**MINUTES  
PLANNING COMMISSION  
CITY OF LAKEWOOD  
12650 DETROIT AVENUE  
AUDITORIUM  
OCTOBER 3, 2024  
6:00 P.M.  
RECORDED**

**4. Docket 10-38-24  
16306 Detroit Ave.  
Jersey Mike's Subs**

Susan Broadwater, Beegan Architectural Design, applicant requests the review and final approval of a planned development consisting of ten townhouse units and one single-family house, pursuant to section 1156 – planned development. The property is in an R2, Single and Two-Family district. (Page 60)

**ARCHITECTURAL SITE PLAN**  
1" = 20'-0"

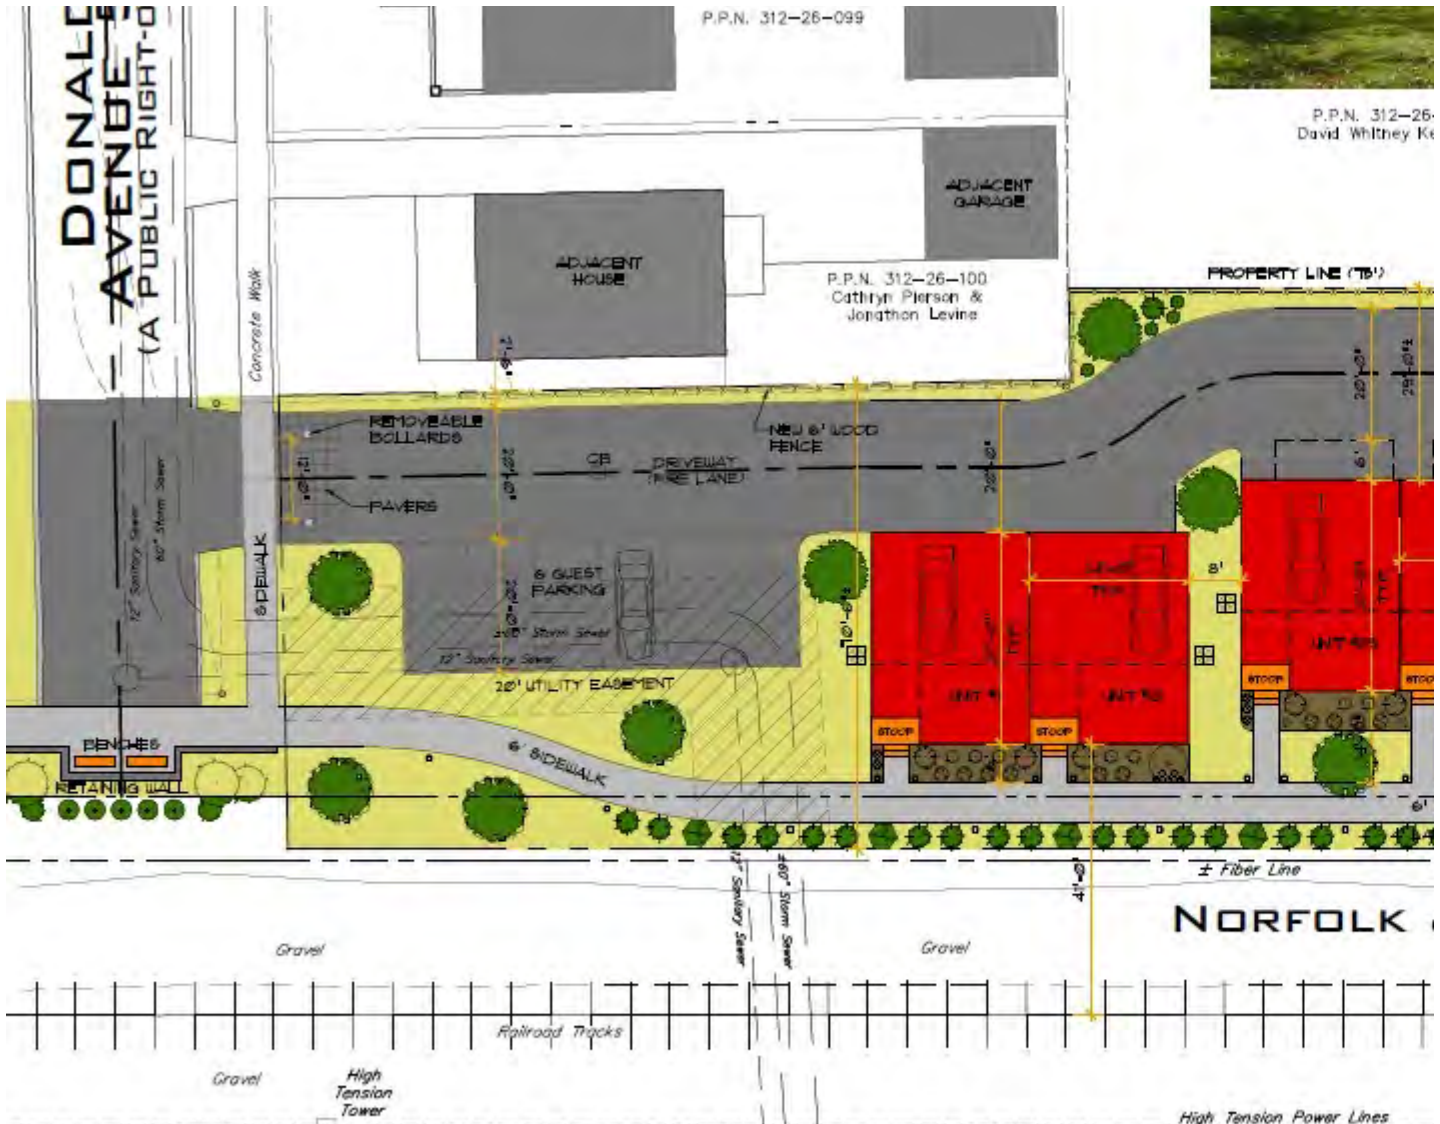
Unfortunately, the latest plans (images below) have not taken into consideration any of the suggestions from the neighbors. We've asked that the road and housing be switched around so that the road would run along the railroad. The latest drawing below shows that they haven't been willing to take that into consideration. Additionally, we've asked that a larger landscape buffer be included, but this has actually been reduced to allow for now a wider two-way street. My understanding is that the buffer dimensions do not fall within the existing code. I also wonder if a street is added why it wouldn't be one-way letting out on Donald to reduce safety concerns of the nearby Cove Park entrance?

**ARCHITECTURAL SITE PLAN**

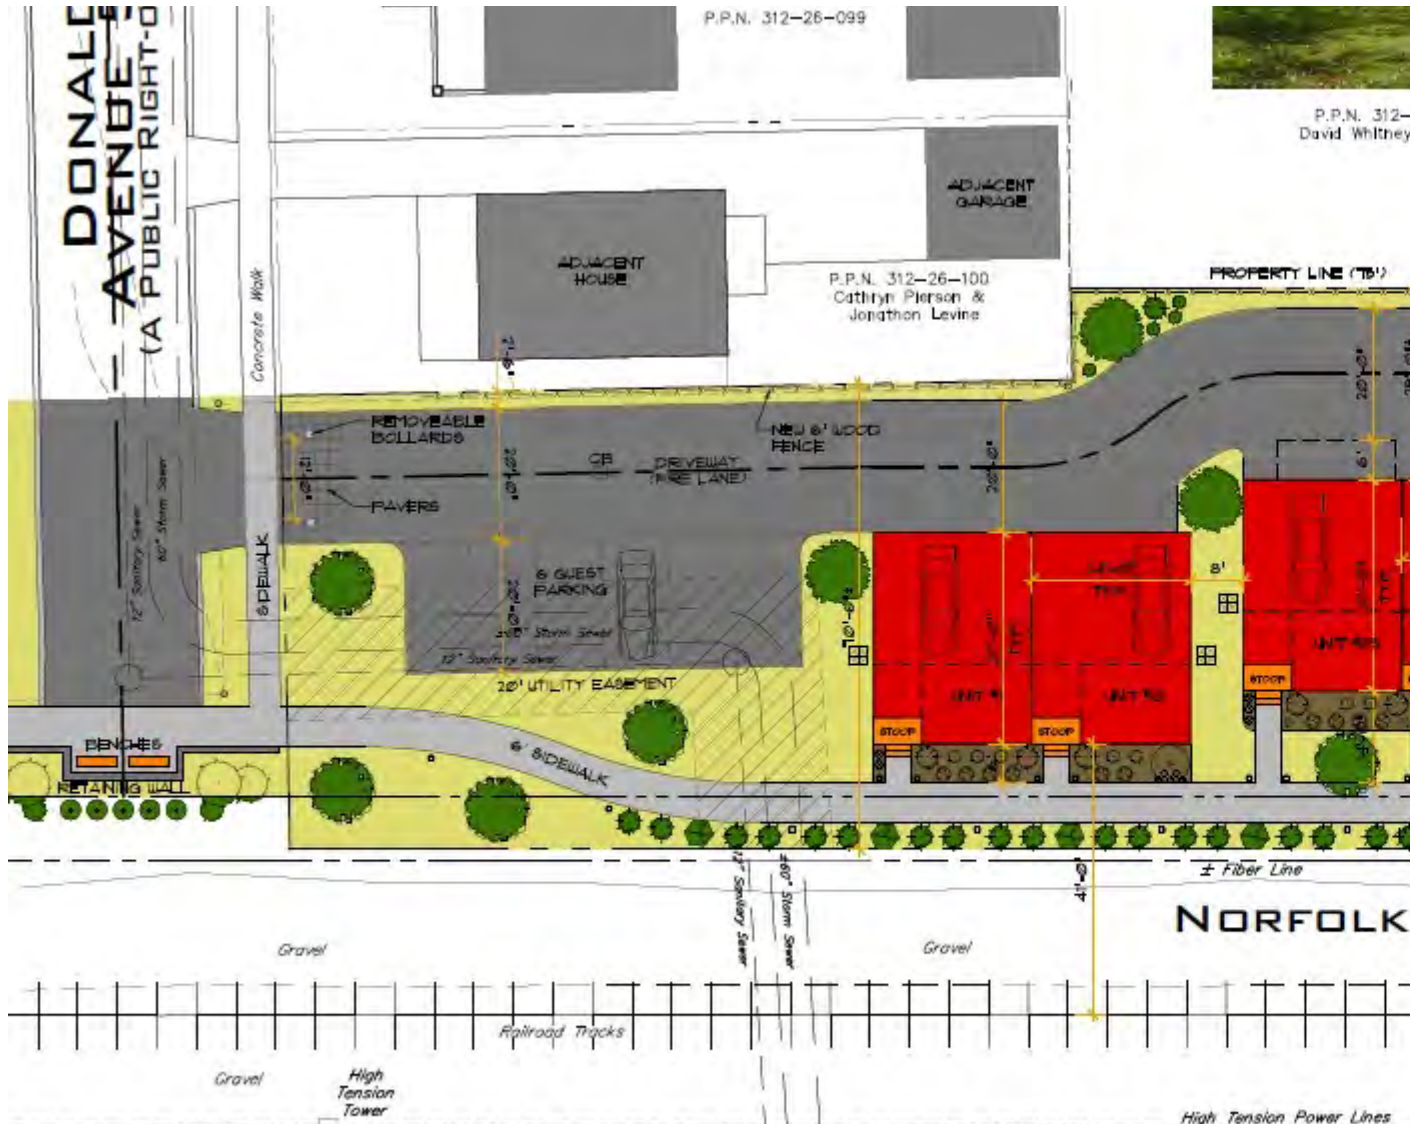
Unfortunately, the latest plans (images below) have not taken into consideration any of the suggestions from the neighbors. We've asked that the road and housing be switched around so that the road would run along the railroad. The latest drawing below shows that they haven't been willing to take that into consideration. Additionally, we've asked that a larger landscape buffer be included, but this has actually been reduced to allow for now a wider two-way street. My understanding is that the buffer dimensions do not fall within the existing code. I also wonder if a street is added why it wouldn't be one-way letting out on Donald to reduce safety concerns of the nearby Cove Park entrance?

**ARCHITECTURAL SITE PLAN**

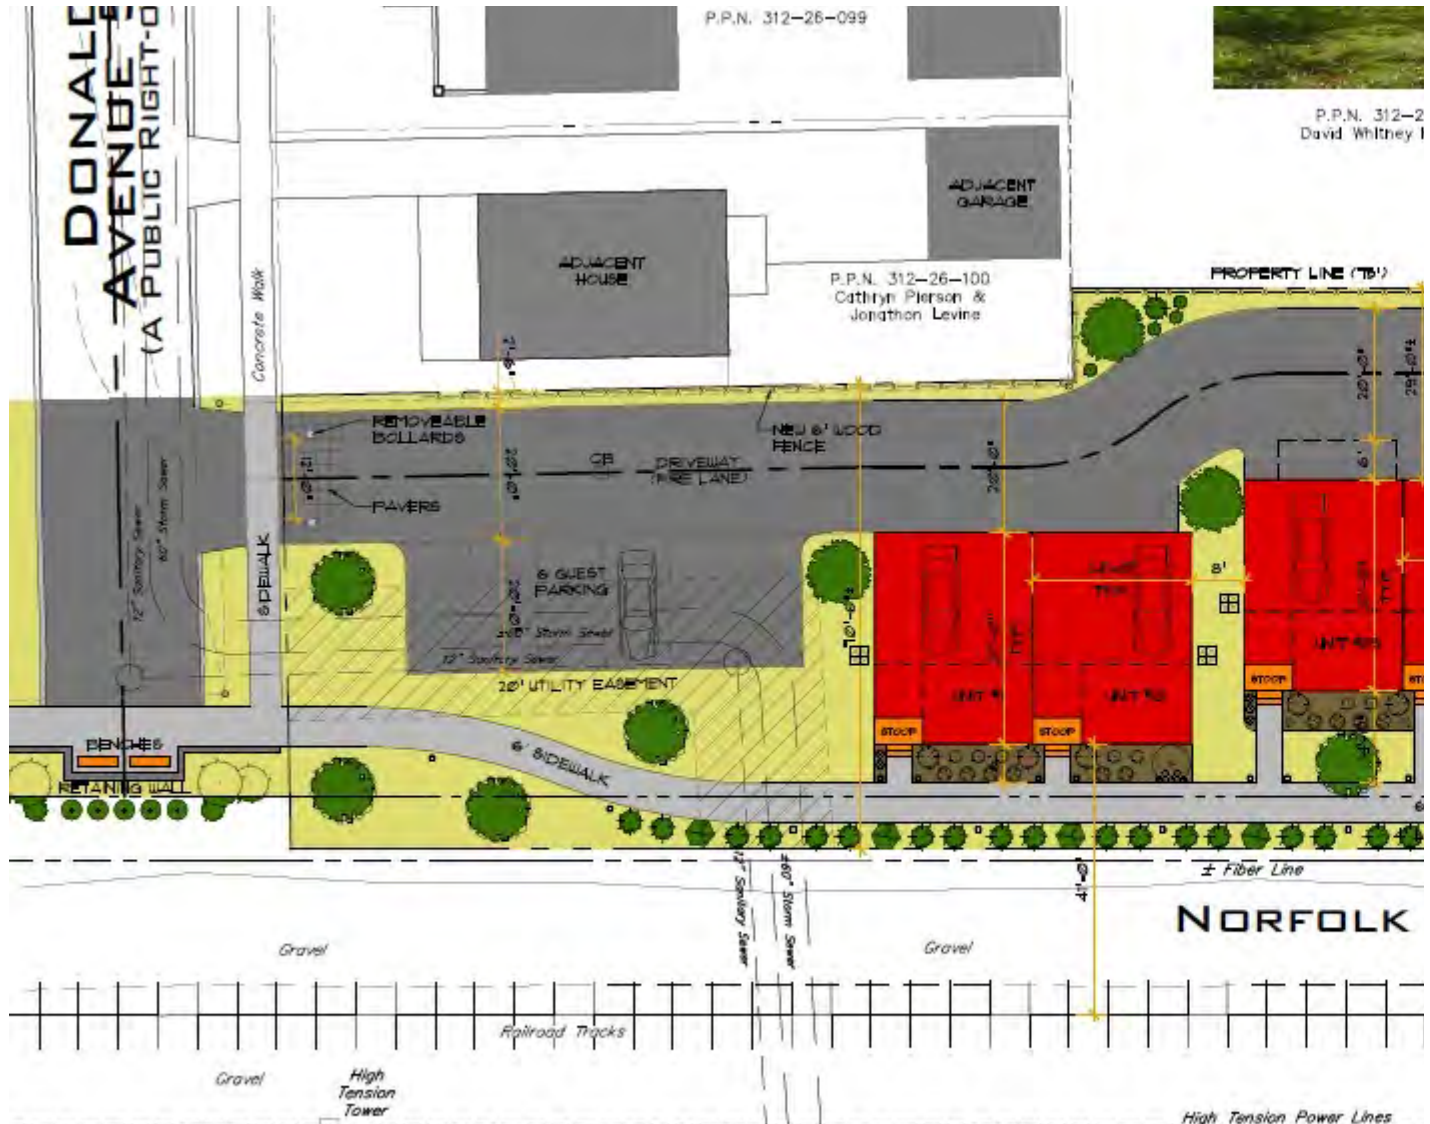
Unfortunately, the latest plans (images below) have not taken into consideration any of the suggestions from the neighbors. We've asked that the road and housing be switched around so that the road would run along the railroad. The latest drawing below shows that they haven't been willing to take that into consideration. Additionally, we've asked that a larger landscape buffer be included, but this has actually been reduced to allow for now a wider two-way street. My understanding is that the buffer dimensions do not fall within the existing code. I also wonder if a street is added why it wouldn't be one-way letting out on Donald to reduce safety concerns of the nearby Cove Park entrance?

APPROXIMATE LAYOUT

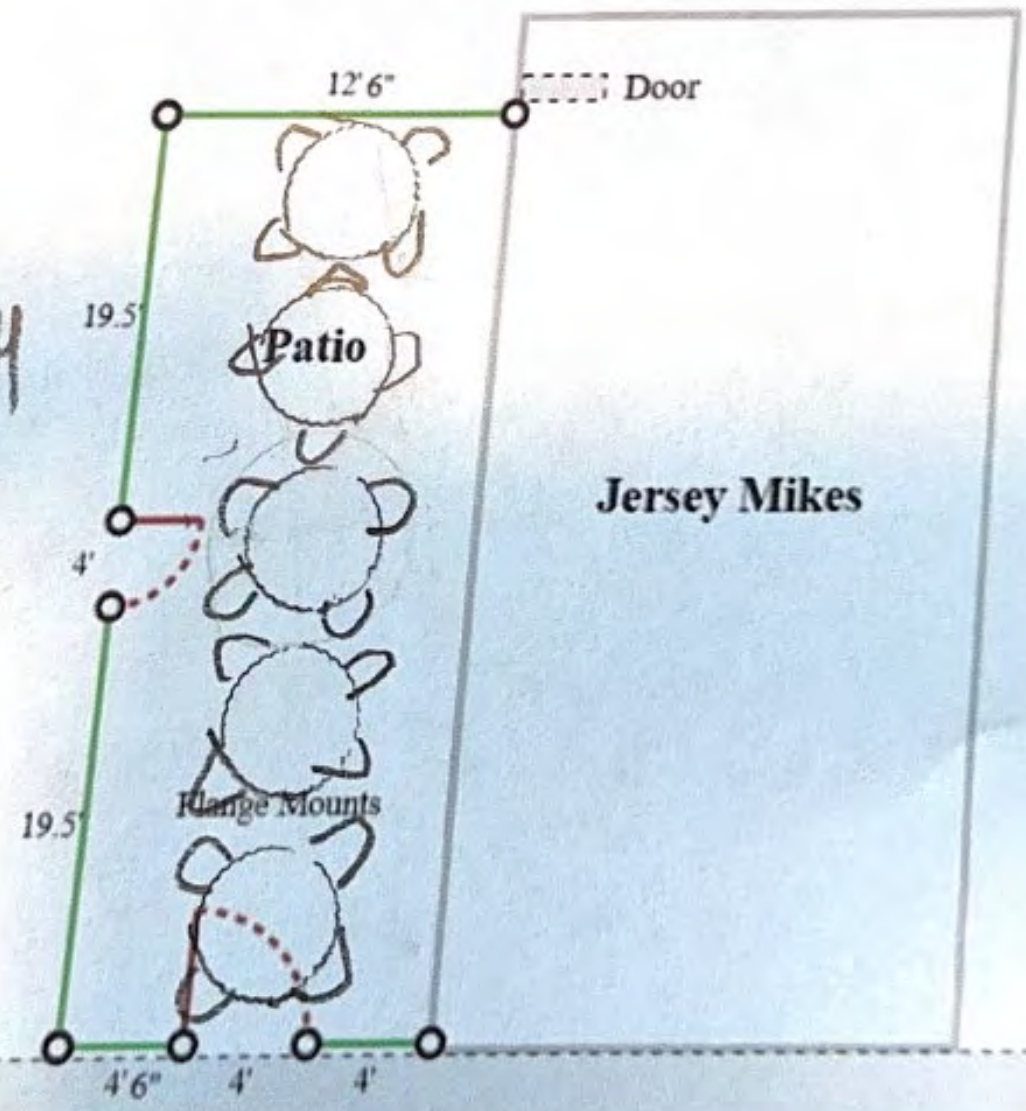
- Will the patio enclosure be locked to prevent after hour use?
  - Yes.
- The dining area is too small for adequate patron circulation with the swing gates and creates limited access to the storefront from the rear parking lot.
- Need to see dimensions.
- Fence would be close to the utility poles.
- Is there a line of sight by staff to the outside dining area?
  - No. Could install cameras.
- Need more details from the applicant before granting approval.
- Consider the elimination of a fence and one table with four chairs.
- Is the area part of the lease for Jersey Mike's Subs?
  - Yes.
- Consider different furniture.

- Elimination of the fence will provide more circulation and space for tables
- Examine different types of furniture
- Utilize the wall – maybe place a bench against it.
- Place planters in the corners
- Want details about trash management.
- Surveillance of the outdoor dining area.
- Dimension details, property lines, lease lines.
